ADDENDUM

PROJECT: Jefferson Community Health Center
Patient Wing and Administration Renovation
Fairbury, Nebraska

AD-2

DATE ISSUED: Friday, January 25, 2013

Special Systems Plan

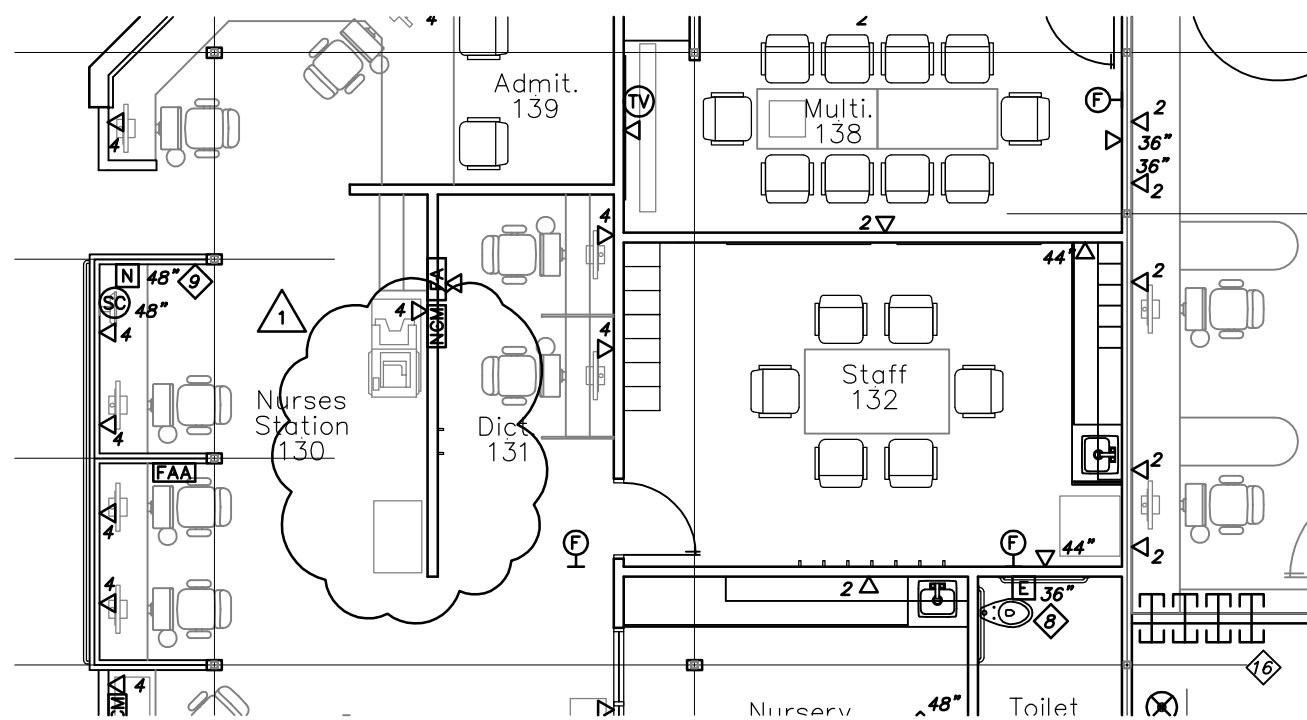
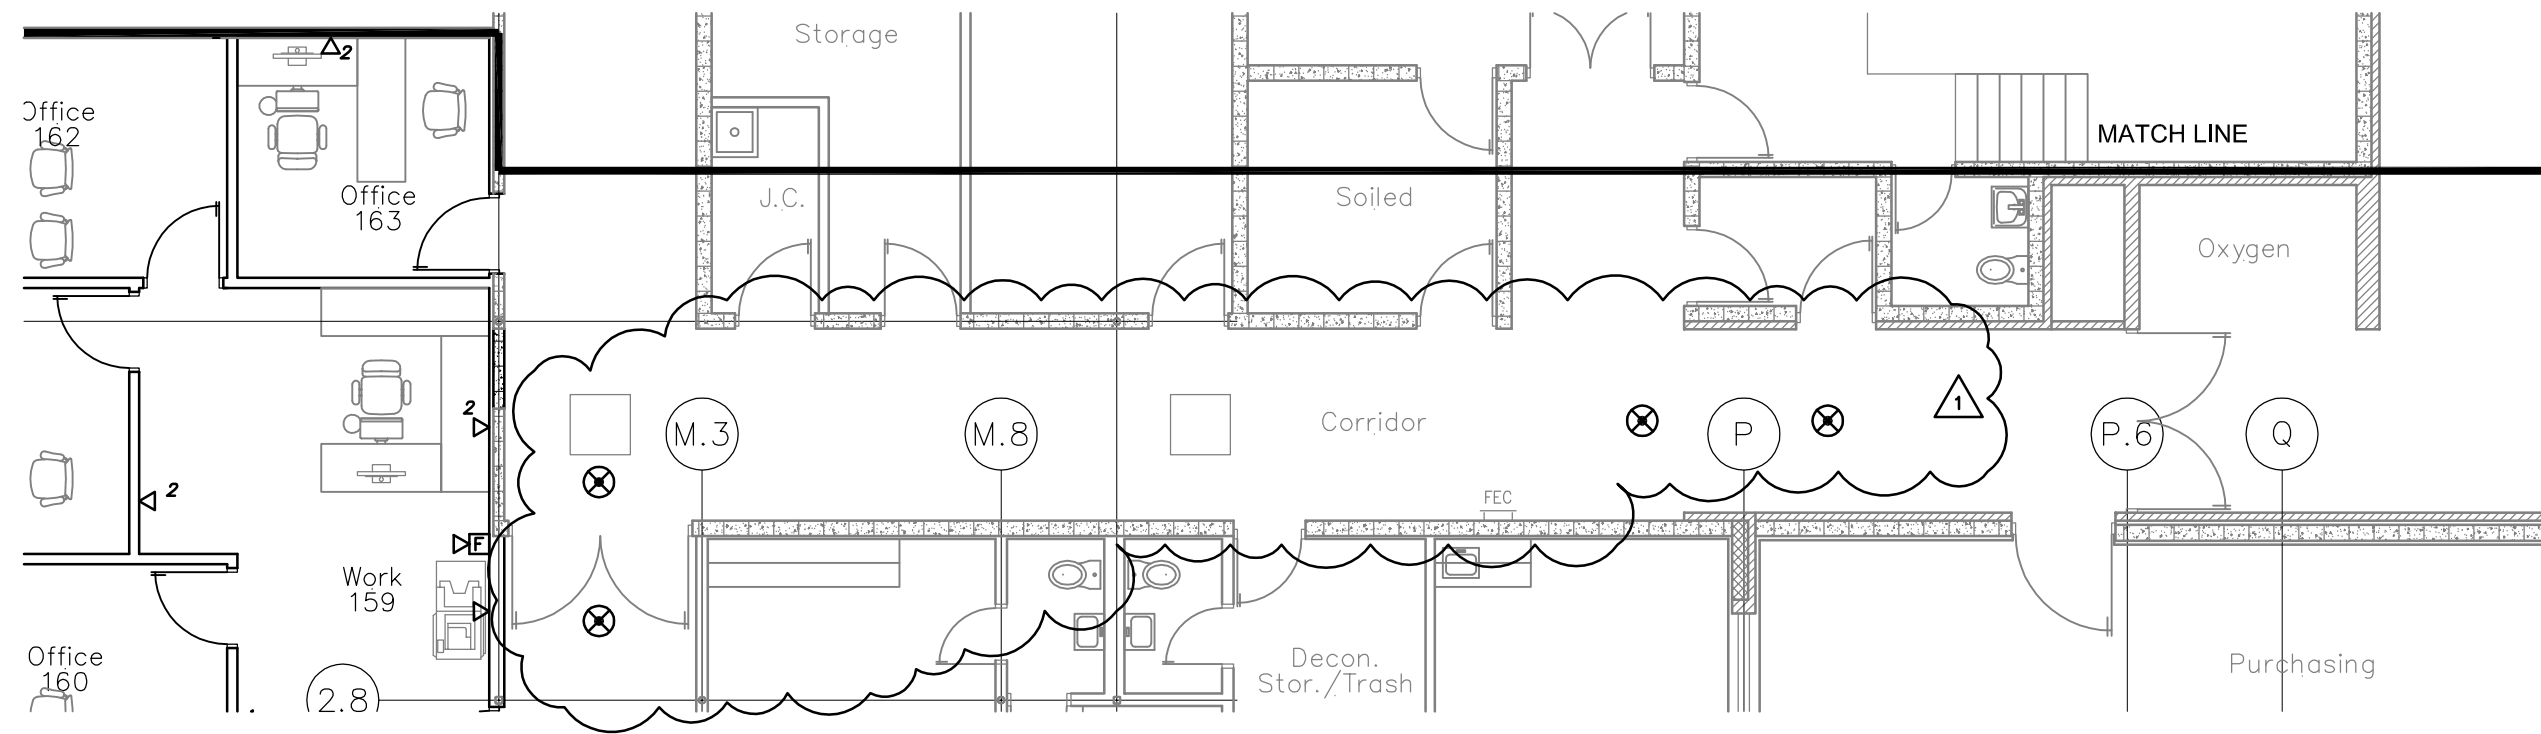
In reference to Sheet E-103, see attached Sheet E-103.1 for revised special systems plan.

Power Plan

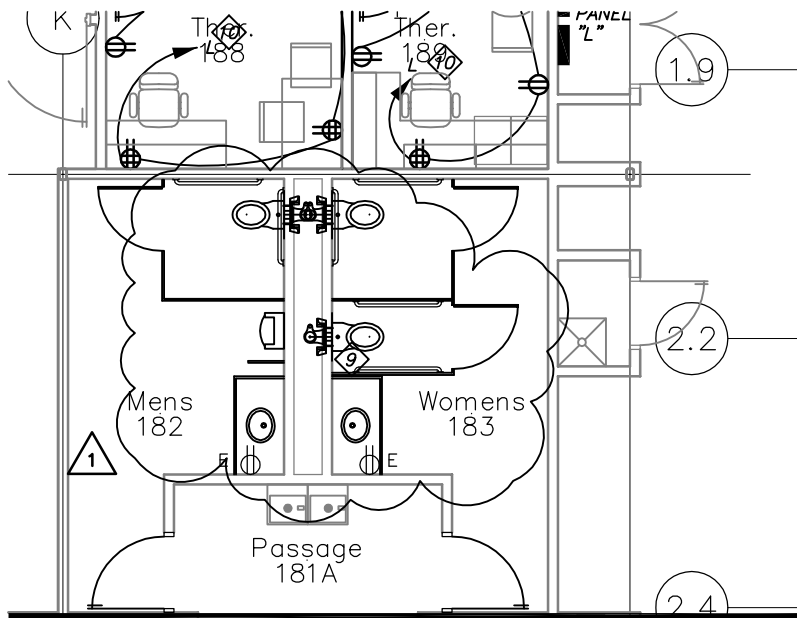
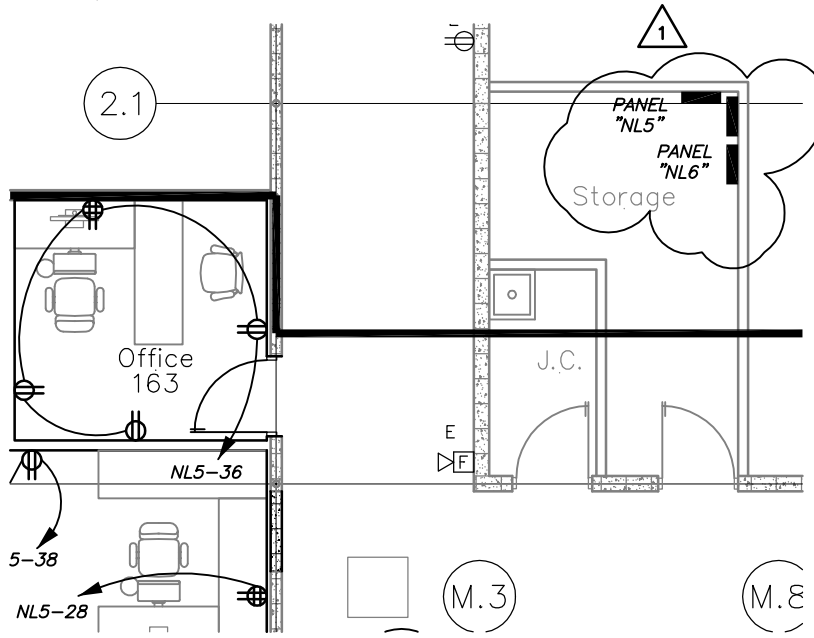
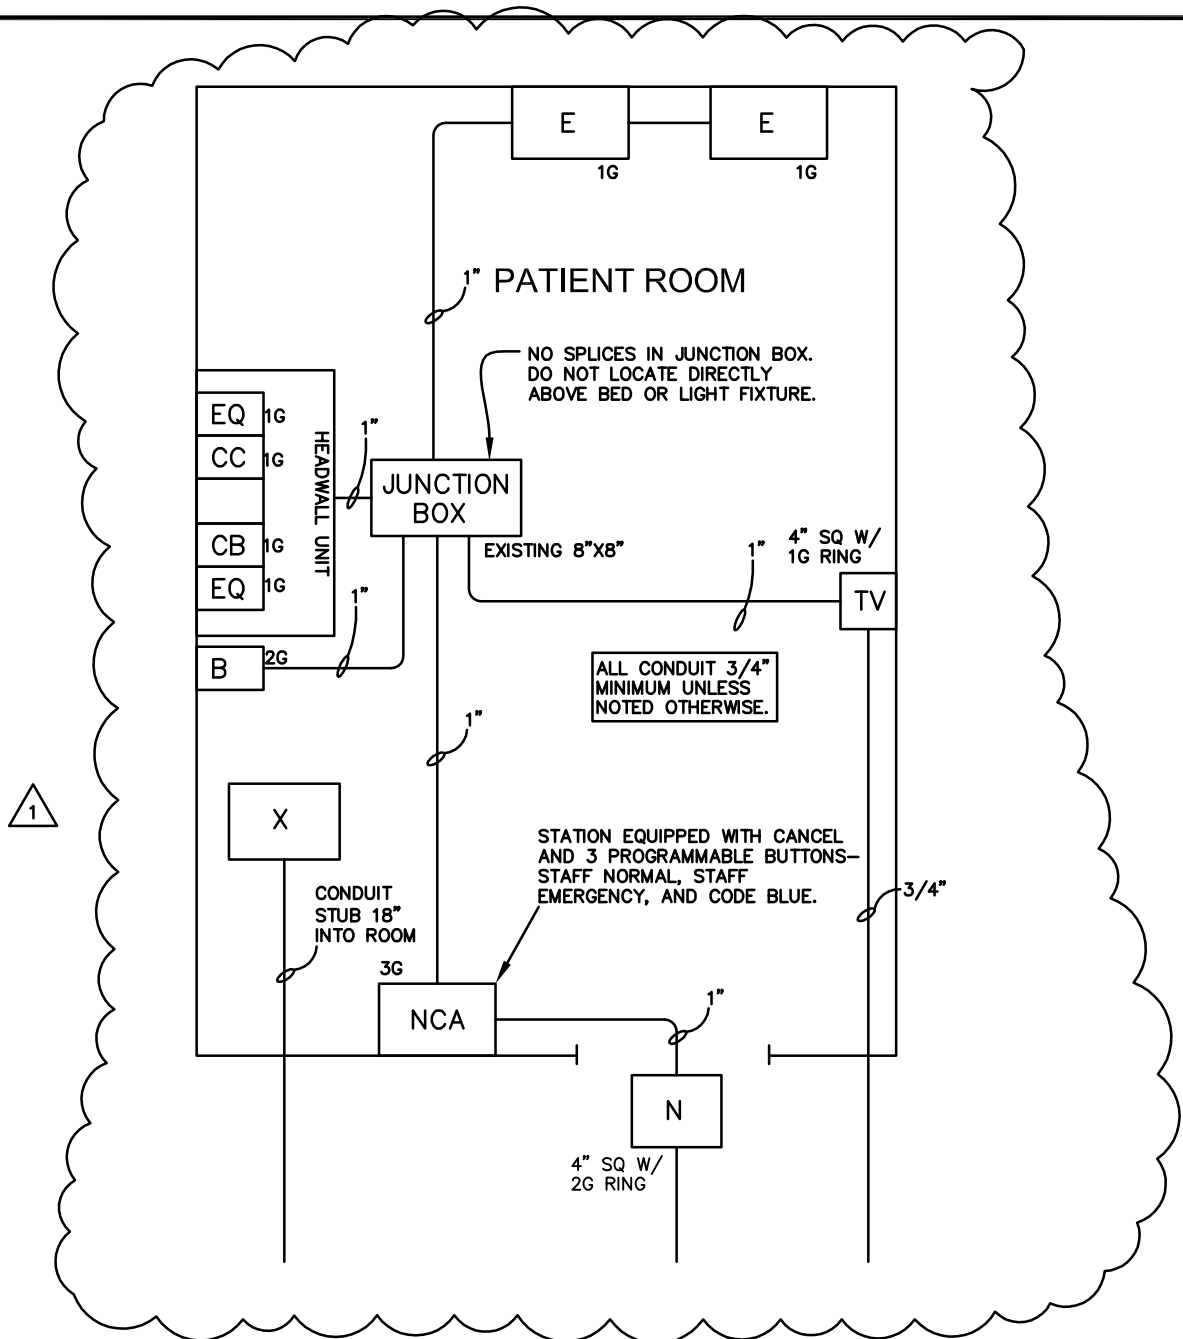
In reference to Sheet E-104, see attached Sheet E-104.1, E-104.2, and E-104.3 for revised Lighting Schedule and Equipment Schedule, revised notes, and new panel locations.

Revised notes reference to cable tray in General Note 10.

Special Systems Rough-In Detail

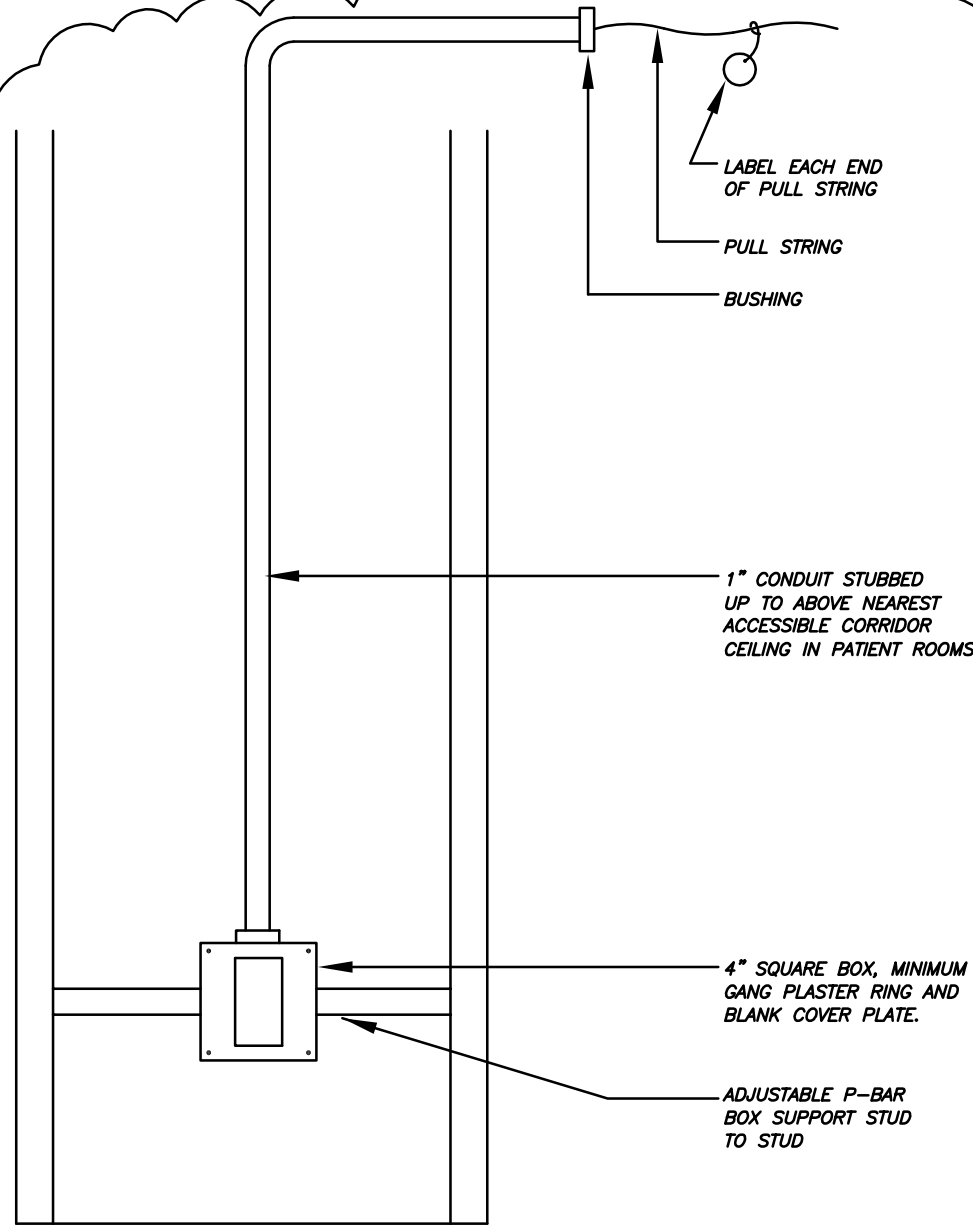
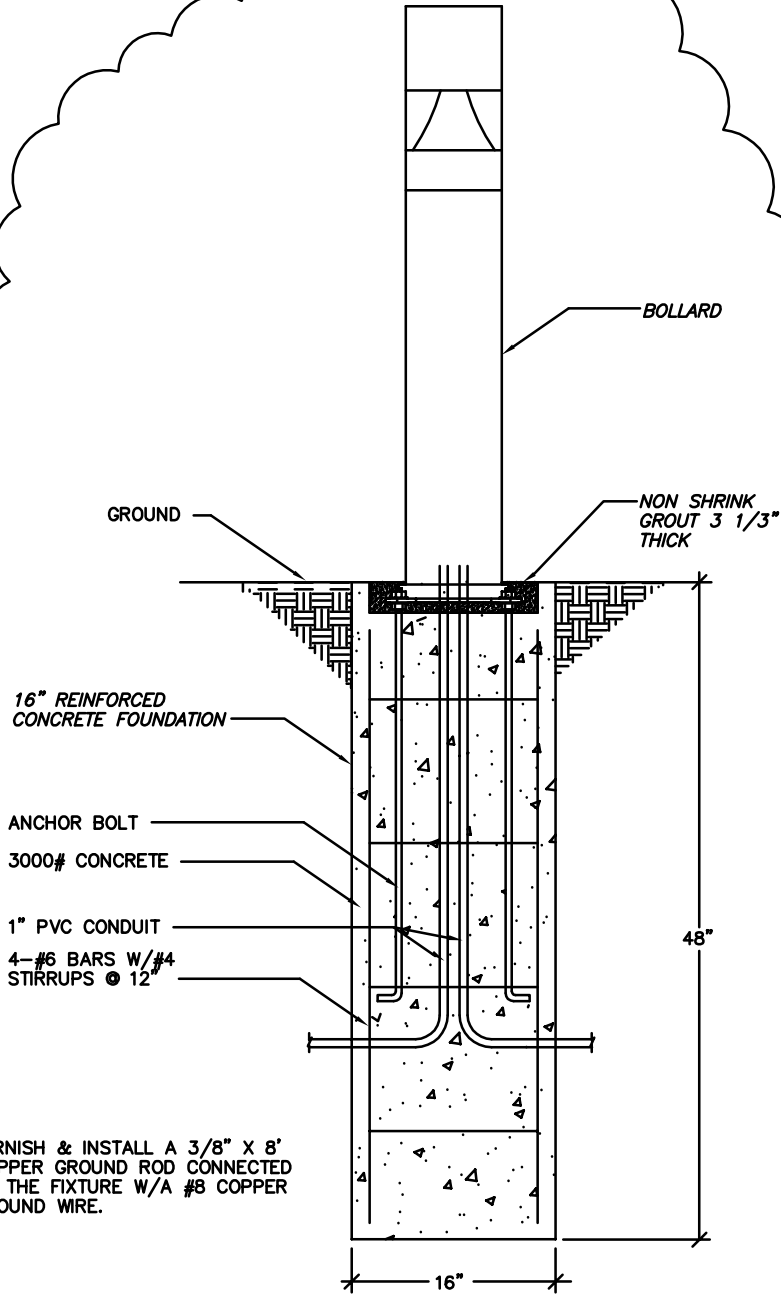
In reference to Sheet E-501, see attached Sheet E-501.1, E-501.2 and E-501.3 for revised detail #2 and added details #4 and #5.

1 Floor Plan - Plumbing - Area C
Scale: 1/8" = 1'-0"

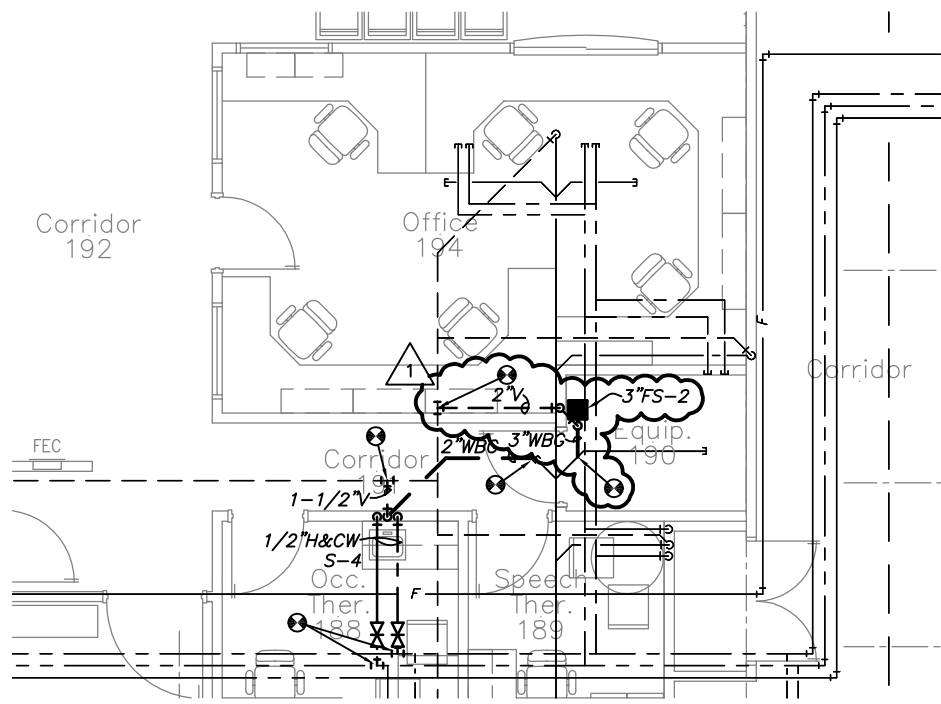
In reference to Sheet P-105, Provide a new floor sink at Equipment Room 190 for emptying the hydroculator located in the Treatment Room. The floor sink shall be J.R. Smith model 3410, with an acid resistant coated solid cover to be removed during use. Fill p-trap of floor sink with mineral oil at completion of first phase of plumbing work. See attached Sheet P-105.1.
